## DEPARTMENT OF PLANNING AND ZONING

Re: DSUP #2016-0008 – 930 North Henry Street  
Completeness Comments

This letter serves to inform you that City staff has completed its review of the Completeness Plan submitted for the above referenced project. The submitted plans, received August 16, 2015, have been deemed **incomplete**. Staff finds that the project in its current form is not ready to advance to the Verification of Completeness phase of the site plan review.

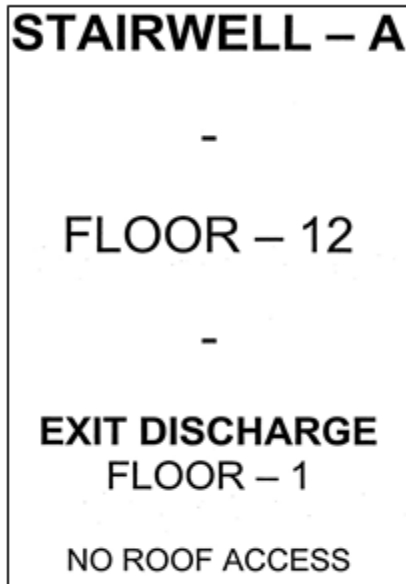
~~11. Show fire apparatus vehicle turning radius based on the following specifications:~~

**Road alignment not changing, existing conditions will remain. This condition has been deleted.**

Ex. Stairway Identification Sign

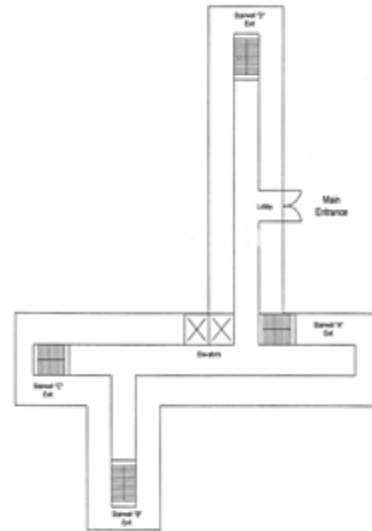
12. Provide Stairway Identification. Stairway identification signs shall be provided at each landing in all interior exit stairways connecting more than three stories. Stairways shall be identified by letter designation starting next to the main entrance with "A" and continuing in a clockwise or left to right pattern using consecutive letters of the alphabet for each additional stairway. Two copies of the stairway signs shall be submitted to the fire official for approval before occupancy.

Stairway signs shall designate the stairway letter, state the floor level, the level of exit discharge, and if there is access or no access to the roof regardless if the access door or roof hatch locks. The bottom of the sign shall be located five (5) feet above the floor landing in a position that is readily visible when the stairwell door is opened or closed. The signs must have lettering that is a minimum of 2 inches but no greater than 4 inches in height. This information may be stenciled directly onto the wall but all lettering must be of a color contrasting with the background stairway wall color.

**Acknowledged by applicant.**
